We thank you for your letter of November 21, 1952, and for the copy of your office report on the failure of the Frenchman Creek Dam occurring April 15, 1952.

Inclosed for your files is a copy of a report on the failure of Frenchman Creek Dam which has been prepared by this office. Copies of the report have been reviewed by offices of the Corps of Engineers, and Mr. T. A. Middlebrooks, Chief of the Soils Branch of the Office of the Chief of Engineers, Washington, D. C. personally visited the site of Frenchman Dam on 17 November 1952.

REPORT ON THE FAILURE OF FRENCHMAN CREEK DAM

FRENCHMAN CREEK DAM FAILURE

PHOTO NO. 21351
DATE 4/15/52
TIME 12:28 P.M.

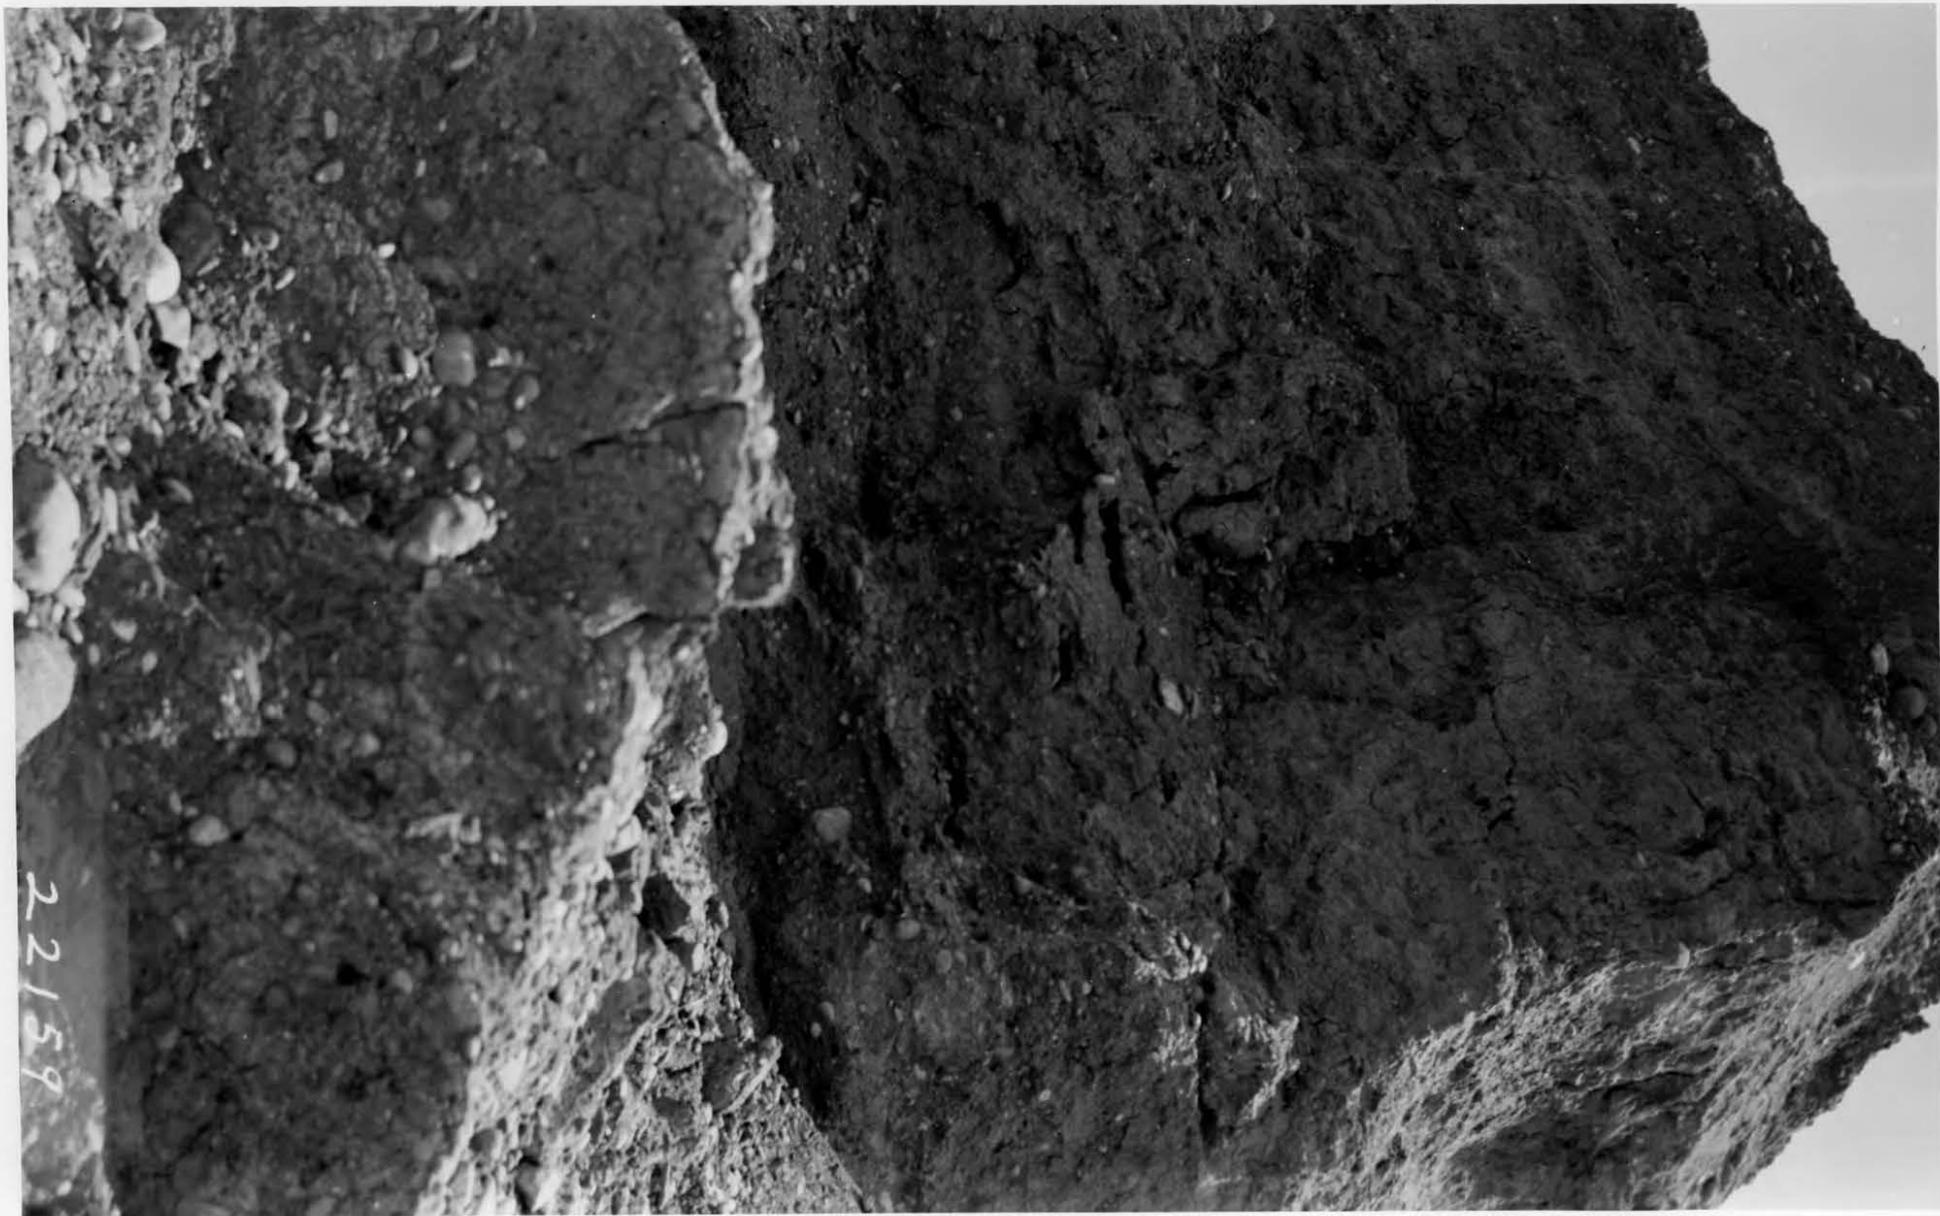
20. About 9:05 AM on 15 April, personnel from Fort Peck District, who were at that time making an aerial reconnaissance of flood conditions at Frenchman Reservoir, noted a wet area on the downstream slopes of the main fill at the contact between the fill and the east retaining wall of the spillway. (See Photo No. 21351) This condition worsened through out the day and by 5:00 PM a large segment of the fill and natural ground adjacent to the spillway retaining wall had been eroded out. (See Photo No. 21364) At 5:40 PM the remaining portion of the fill adjacent to the spillway had washed out and in a short time a crevasse 100 feet

Aerial view of Dam looking upstream at point
where seepage was first noticed.
